3.7.17 [ Spent Fuel Pool Storage ]

SEQUOYAH UNIT 2

Westinghouse STS

Figure 3.7.15-1  
Arrangements of Fuel Storage Regions in the Sequoyah Spent Fuel Storage Pool

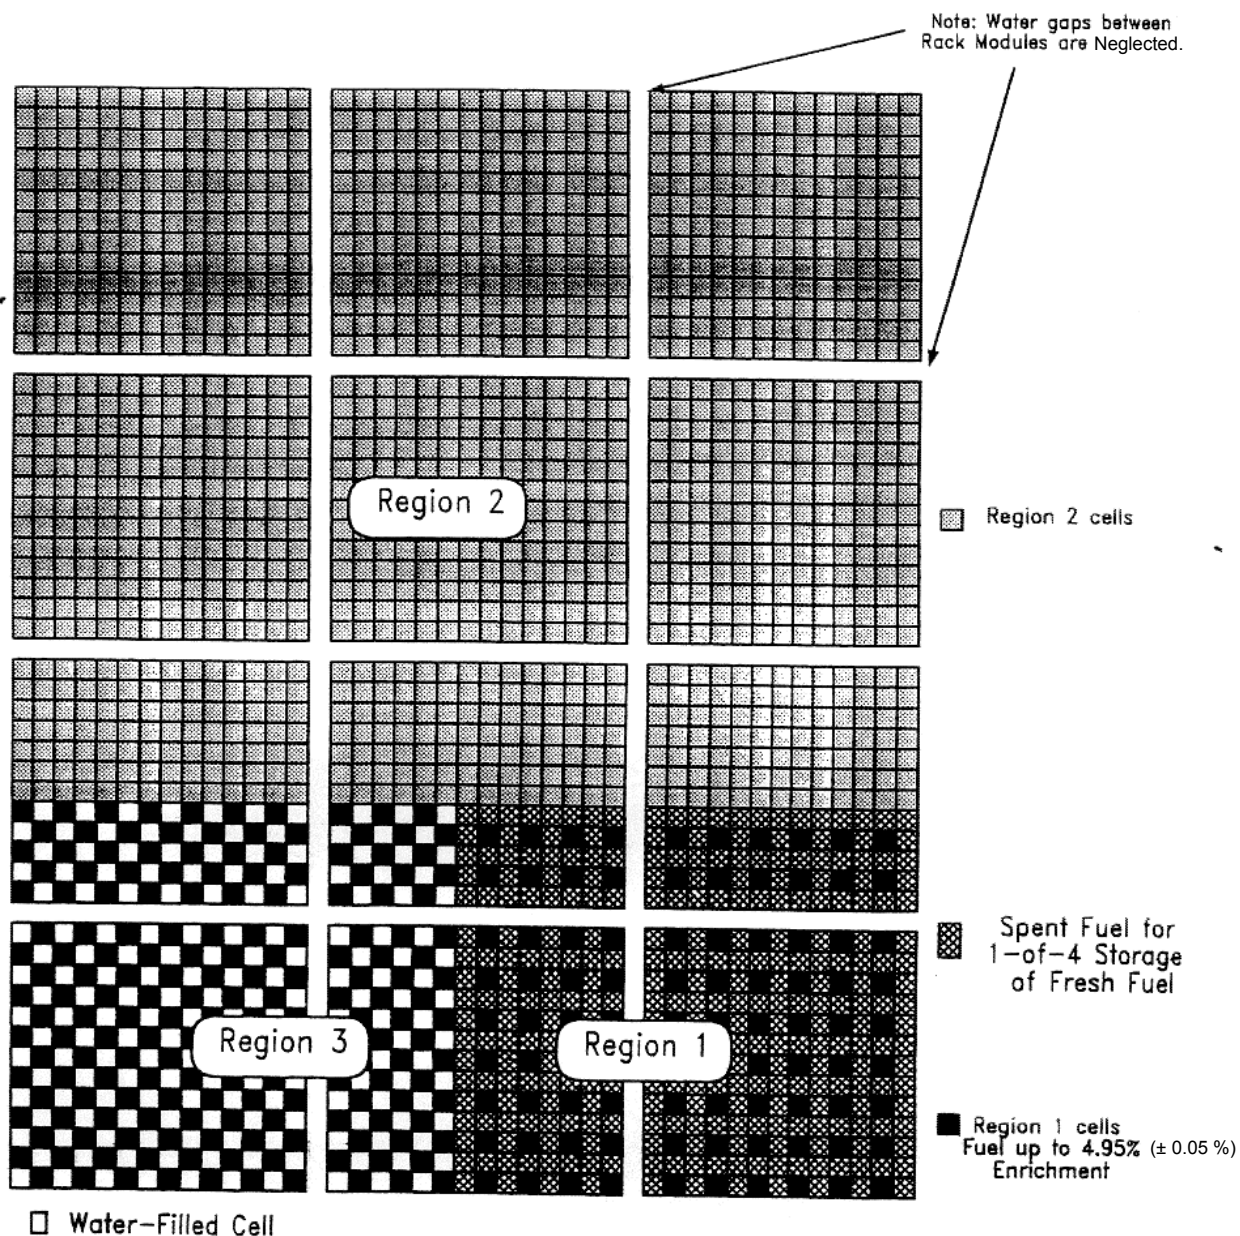
3  
**INSERT 3**

Note: The edges of the sketch above are not necessarily the edges of the pool. The Regions may appear anywhere in the pool and in any orientation, subject to the restrictions in LCO 3.7.15.

Figure 3.7.15-2  
Acceptable Spent Fuel Pool Loading Patterns for Checkerboard Storage  
of Fresh and Spent Fuel Assemblies – Example

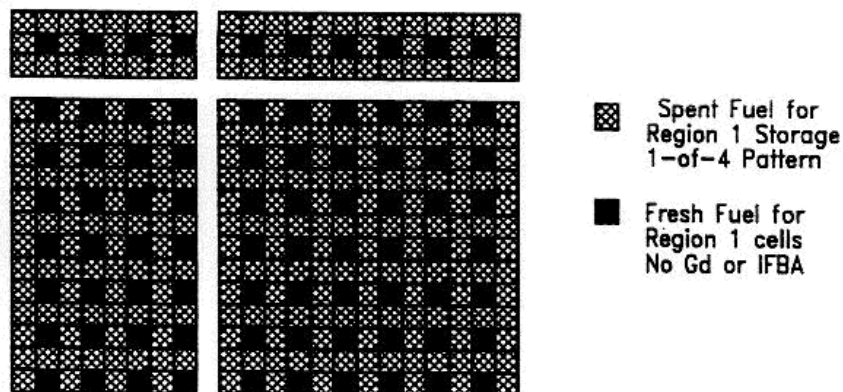
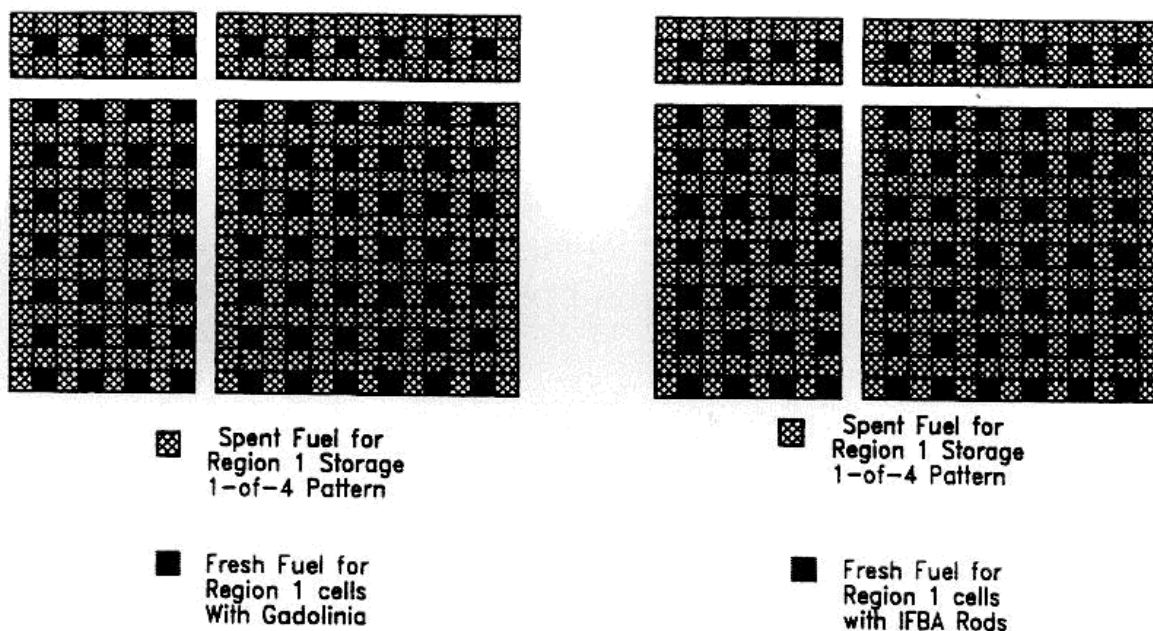
NOTE: WHEN CREDIT IS TAKEN FOR GADOLINIA OR IFBA RODS IN FRESH ASSEMBLIES THE SPENT FUEL ASSEMBLIES NEED NOT HAVE CONTAINED GADOLINIA OR IFBA RODS..

Figure 3.7.15-3  
3-Dimensional Plot of Minimum Fuel Burnups in Region 1  
For Enrichments and/or Cooling Times

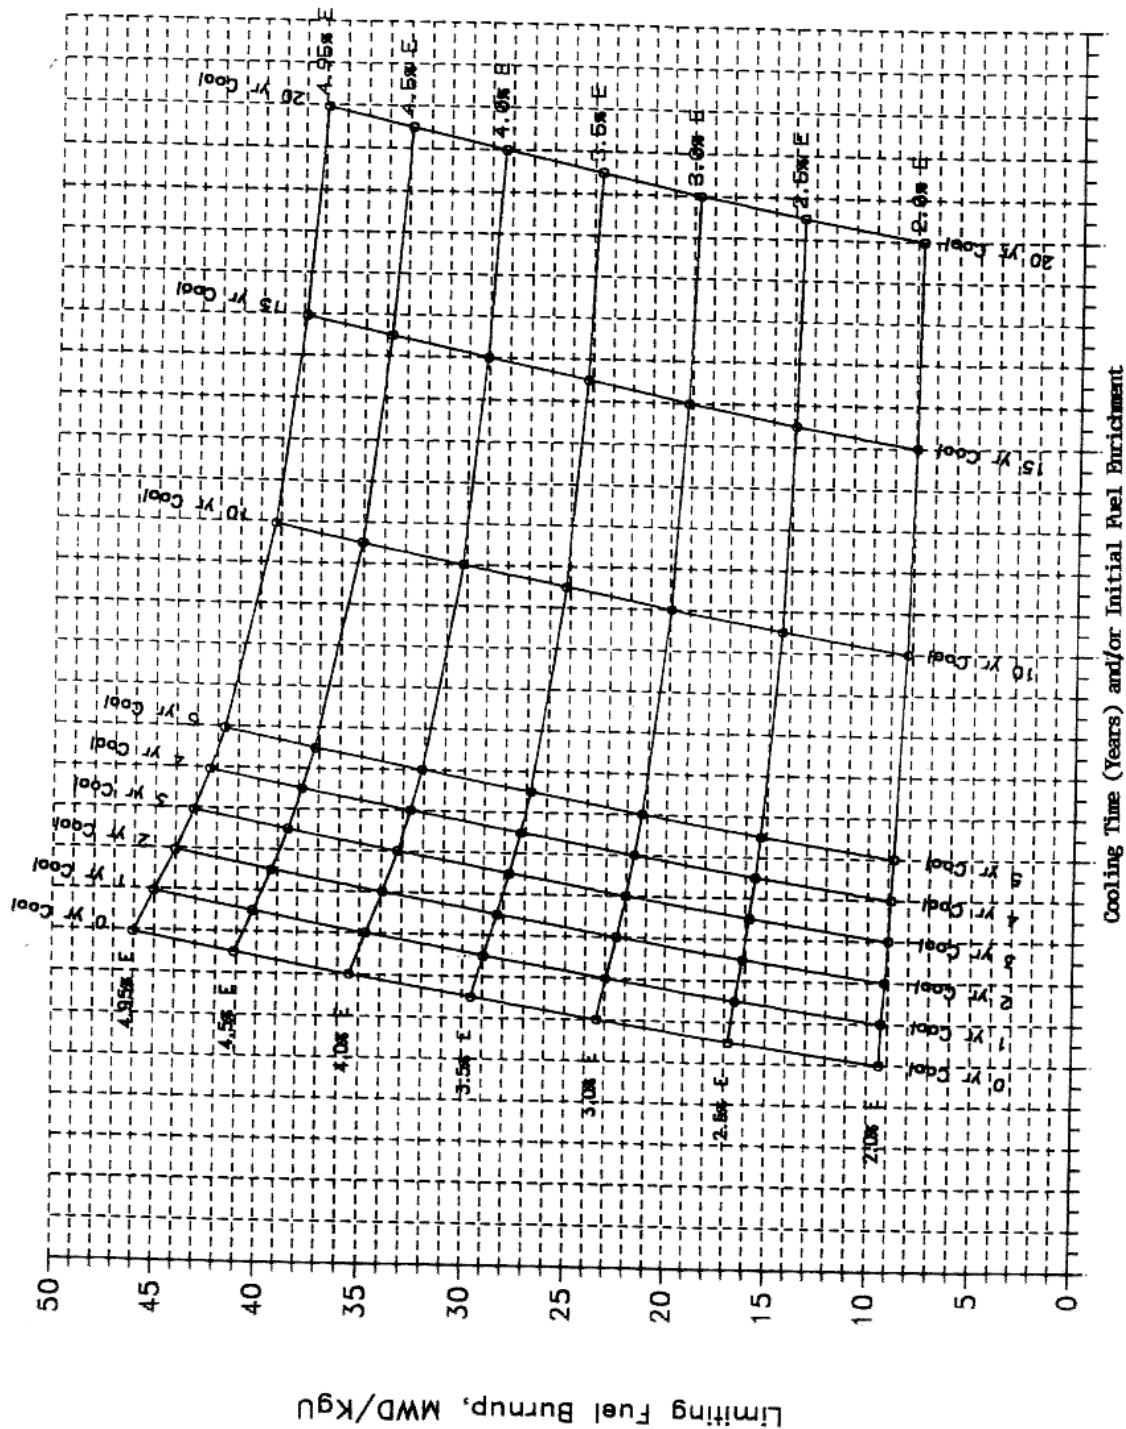
**INSERT 3 (Continued)**

Figure 3.7.15-4  
3-Dimensional Plot of Minimum Fuel Burnups in Region 2  
For Enrichments and Cooling Times

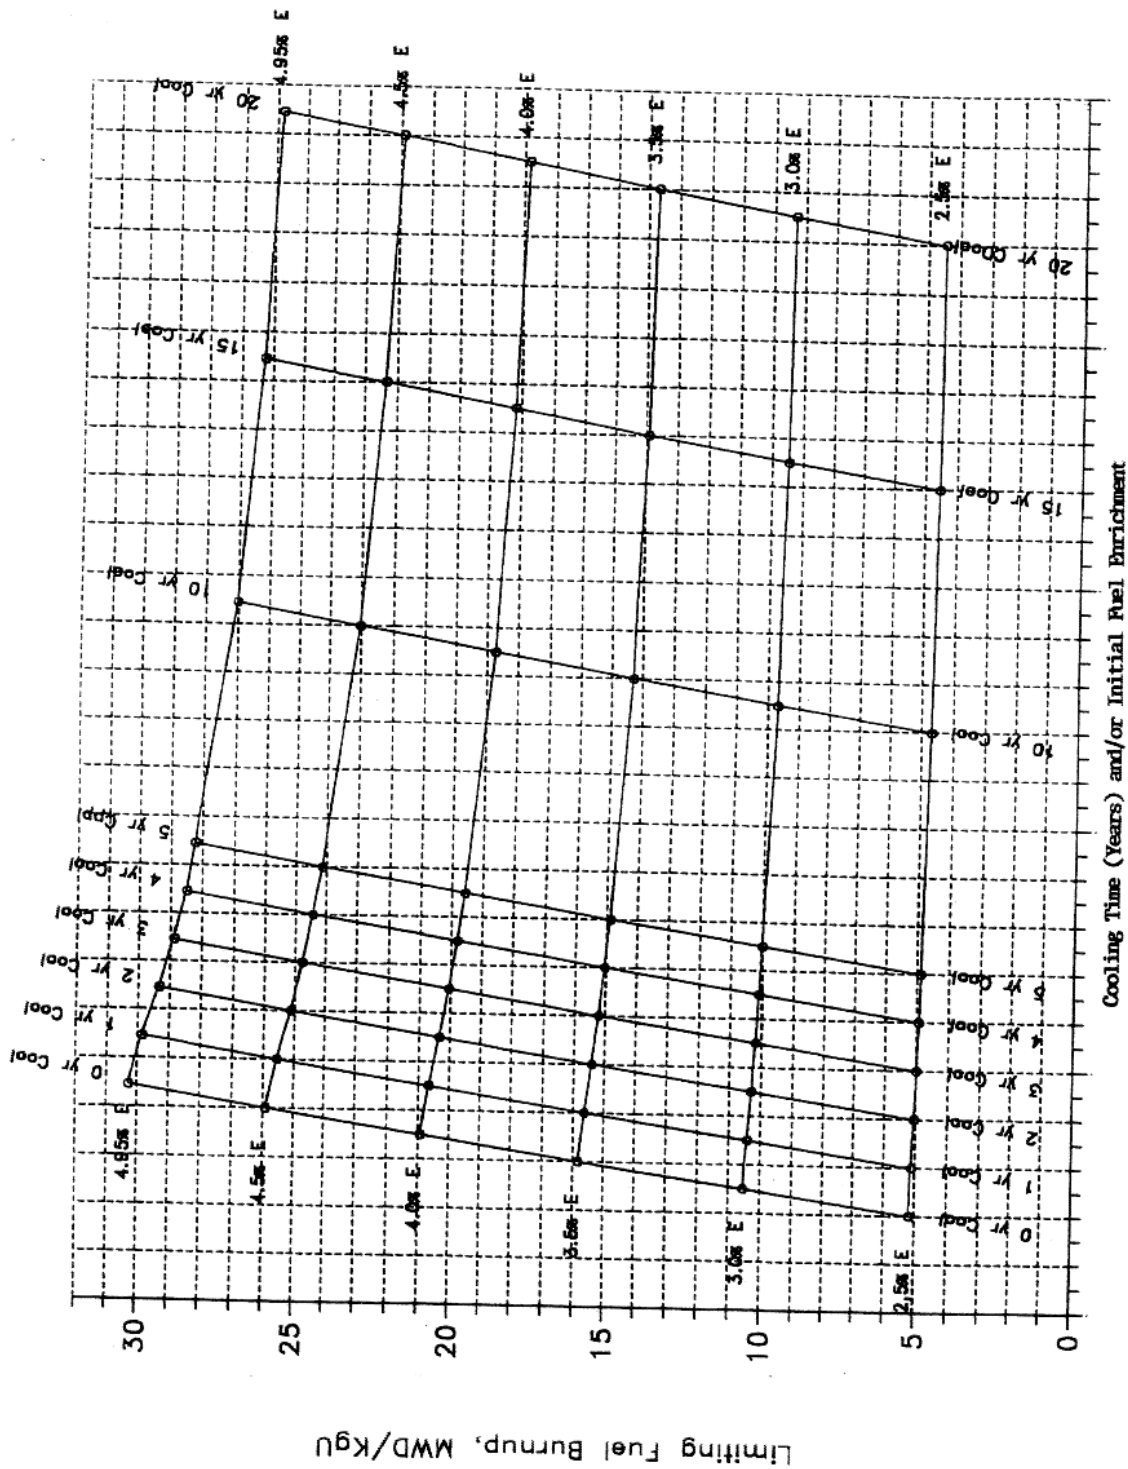
**INSERT 3 (Continued)**
